#### Service information

## Reference no.: SDA\_96603

Errorcode 15 in Intuita line

#### Image 1

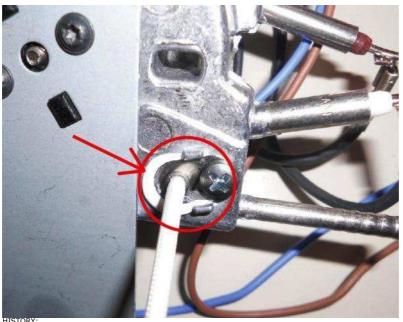
INFO: Set shows error code 15 in logfile.

CURE: In Intuita line up to serial number TW901247552283: Replace the thermostats if they are interrupted. Check the presence of thermo conductive paste on the temperature sensor and in case add more paste on it seat. The thermo conductive paste must exit slightly from the hole during temperature sensor insertion in the same, the leakage of dough creates a collar around the sensor visible from the Image 1.
